IEEE 802.16 Working Group on Broadband Wireless Access

To: IP-OFDMA Evaluation Groups

LIST OF QUESTIONS AND ANSWERS ON IP-OFDMA CHARACTERISTICS AND PERFORMANCE

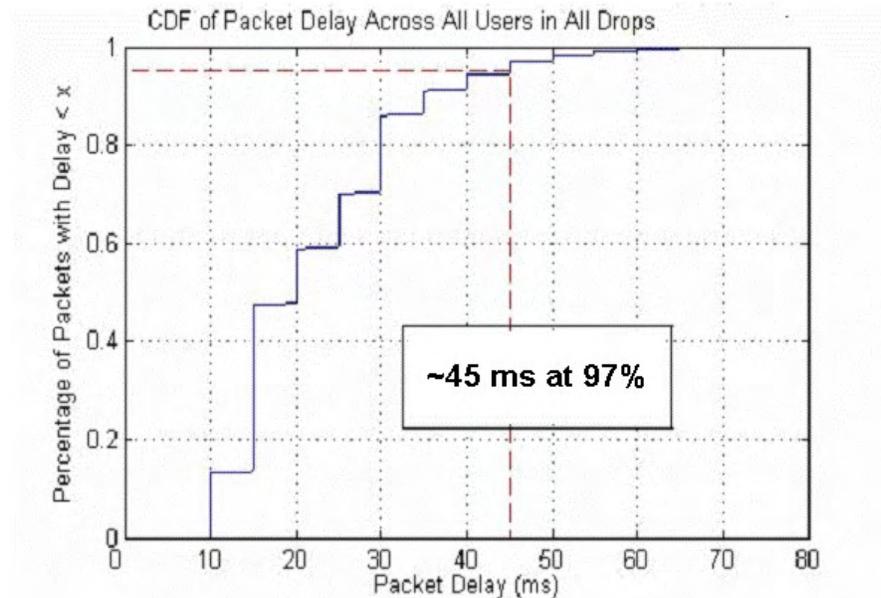
Q: Results are given with a model using Vehicular path loss and Pedestrian B3 channel model which is mixing environment information. What should be used along with the Ped B3 channel is the corresponding ITU pedestrian path loss model and alternatively a vehicular channel model should be used with the ITU vehicular path loss model. Results are to be given for each test environment indicated on the cover sheet (Indoor, Outdoor to Indoor Pedestrian, Vehicular). Furthermore, the deployment models in Annex 2 of M.1225 are to be used. The results are to be supplied using 1% blocking and 50% Voice Activity Detection, however, the submission used 2% blocking and 40% VAD (page 54, section 2.3.1.3).

A: The results in the proposal are based on widely-accepted industry channel/propagation model combinations that are currently more popular than the original ITU M.1225 combinations. Please note the additional simulation results in Appendix 1 of this document that fully comply with the pathloss model/ITU channel combinations. With respect to the comment on the voice simulation assumptions, please see the response to a related question also within the comments in A3.1.1.1.

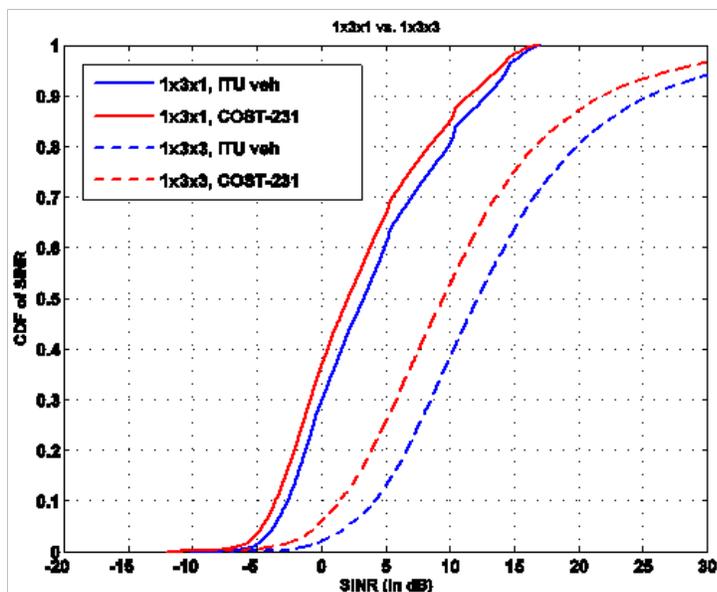
Q: Clarify which codec is used since 4 options are listed. Explain why is 40% voice activity used instead of 50% as required by M.1225?

A: The codec used in the simulations is the G.729 with 20 bytes of voice payload generated every 20msec. All users are assumed to have the same codec (G.729). The voice activity factor (VAF) was chosen to be equal to 40% as that seemed to be the more widely-used value. With VAF of 50% the capacity will be somewhat reduced because it will be partly offset by the reduced overheads in each frame.

A3.2.3:

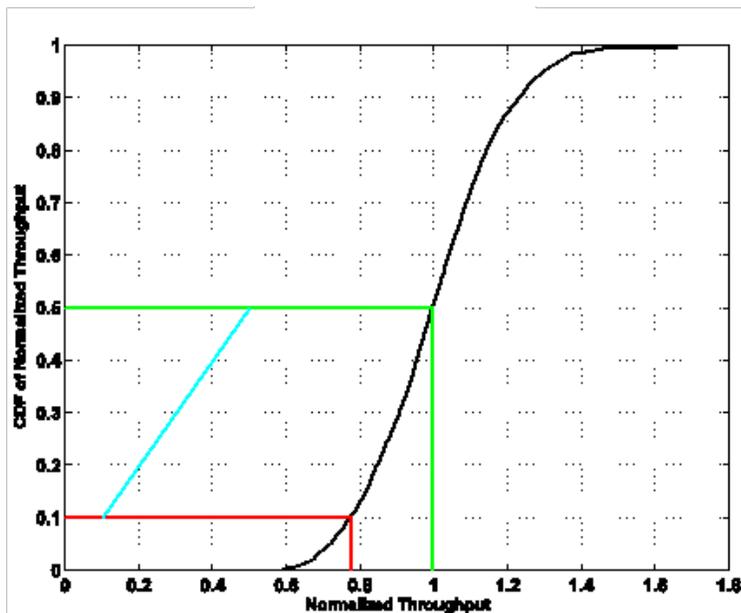
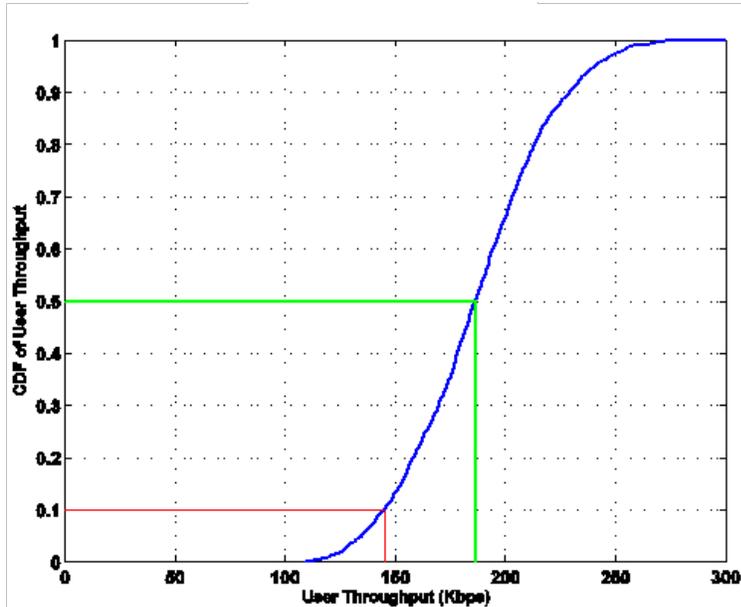
Q: What needs to be stated here also is that the UL power control is message based and each message is 44 bits. What needs to be evaluated here is that how many users in a fully loaded cell can be power controlled at the full PC rate or equivalently, what is the maximum PC rate that can be used for a fully loaded cell/sector, and whether that will be sufficient to provide the expected performance.

A: As stated in A1.2.22.2, 200 Hz is the max possible power control rate and typically is much less than 200Hz, around 10-20 Hz. At 20 Hz, the approximately 1 kbit/s overhead, please see the response to a related question in A1.2.7, amounts to less than 1% of the average user throughput in a SIMO deployment, i.e., the impact of the power control overhead on the system capacity is very low.
